NORTHERN STATES POWER COMPANY  
PRAIRIE ISLAND NUCLEAR GENERATING PLANT

DOCKET Nos. 50-282  
50-306

REQUEST FOR AMENDMENT TO  
OPERATING LICENSES DPR-42 & DPR-60

LICENSE AMENDMENT REQUEST DATED May 7, 1997  
Amendment of Spent Fuel Pool Special Ventilation System Specifications

FIGURE 1  
EXHIBIT A  
SPENT FUEL POOL ENCLOSURE

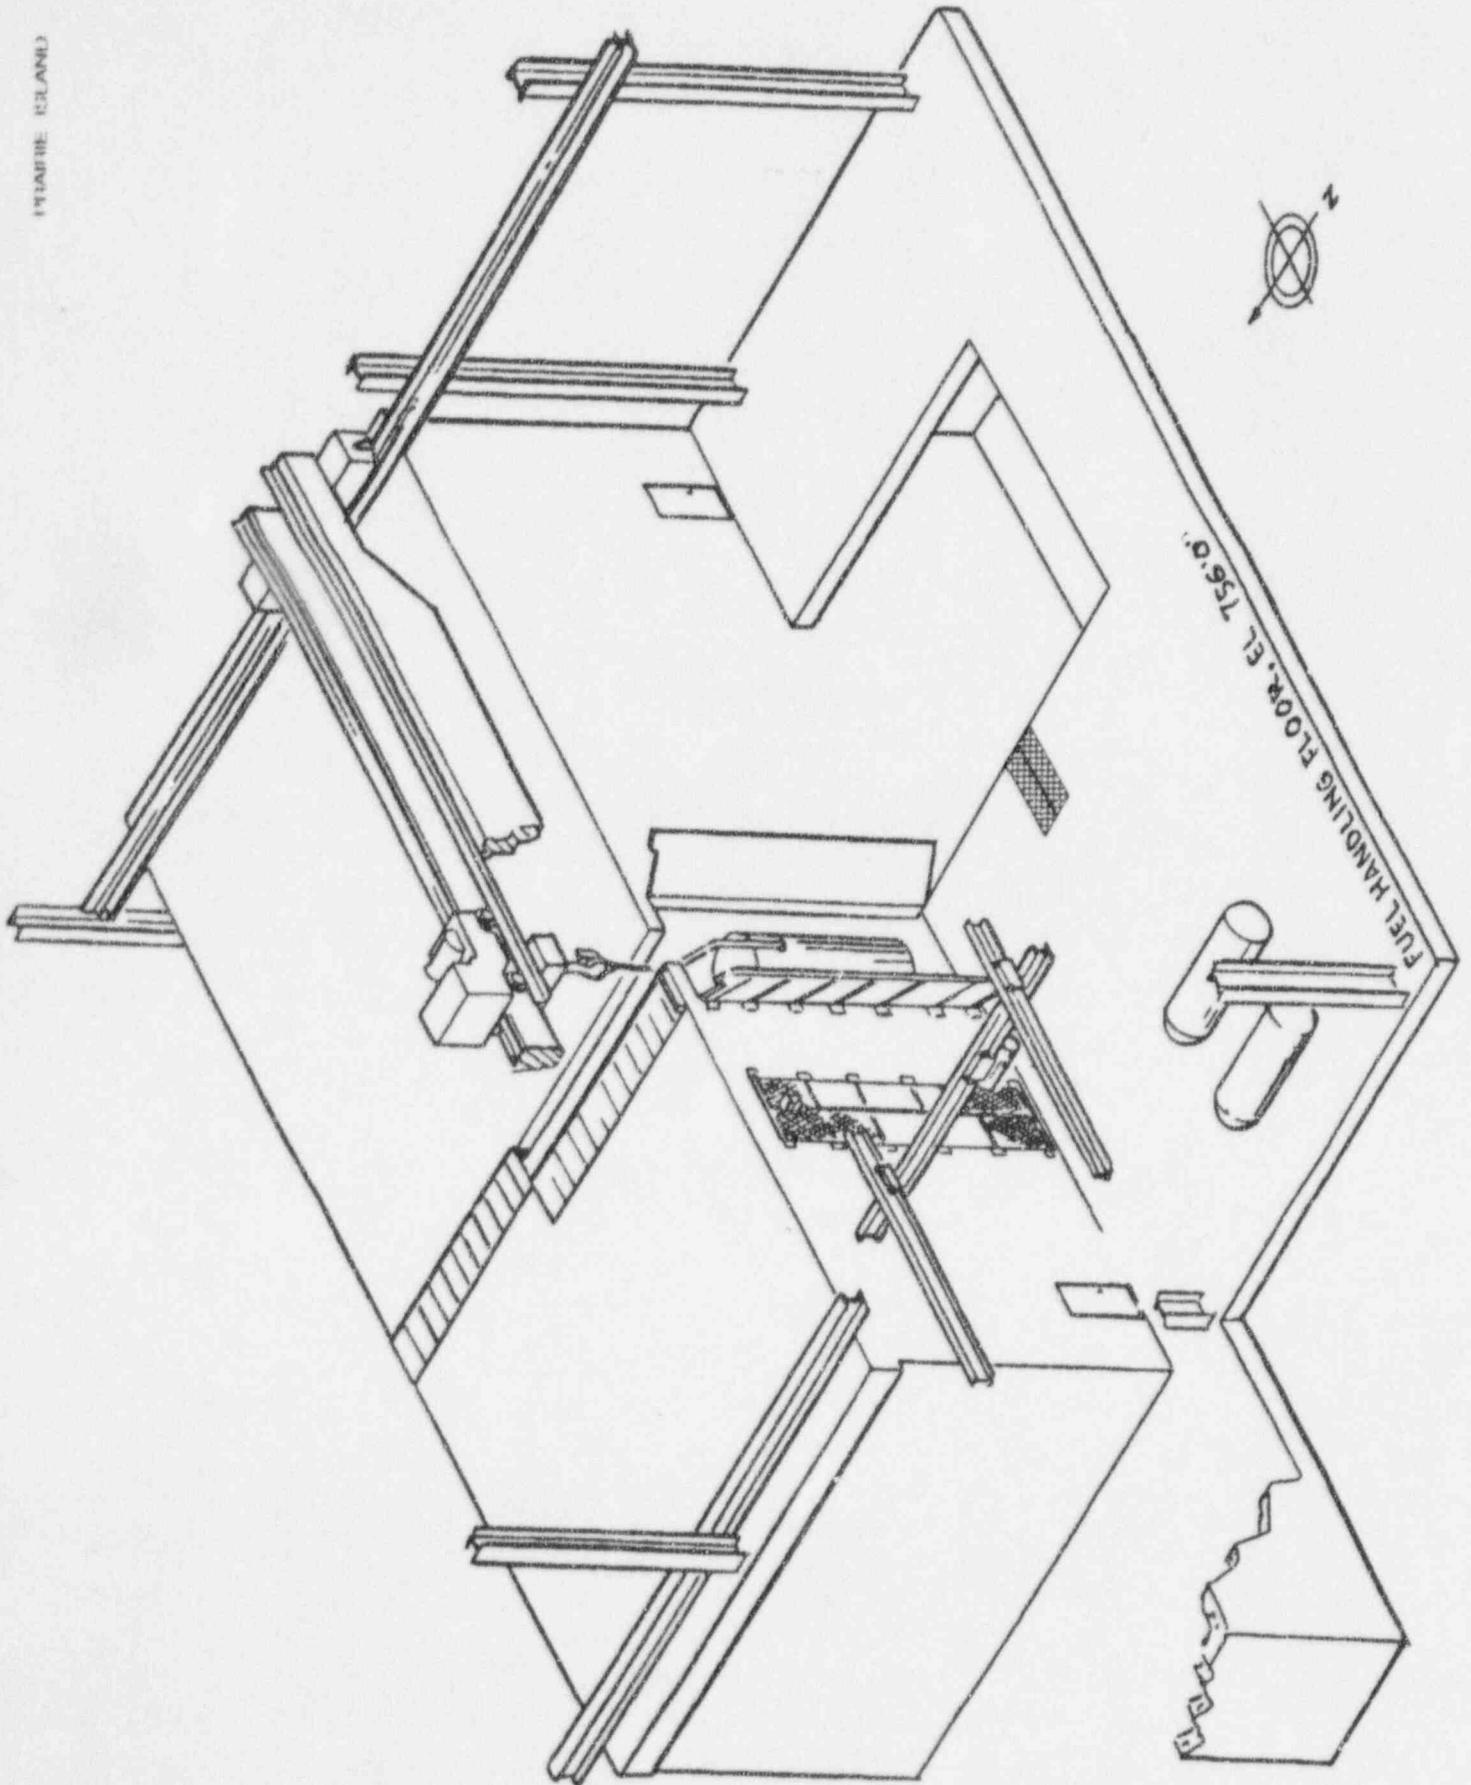
Figure 1 shows the auxiliary building crane moving a load into the spent fuel pool enclosure. In order for the auxiliary building crane to move loads into the spent fuel pool enclosure or to move loads to the auxiliary building central court, north of the spent fuel pool enclosure, the large access doors and the roof slot doors of the spent fuel pool enclosure must be open.
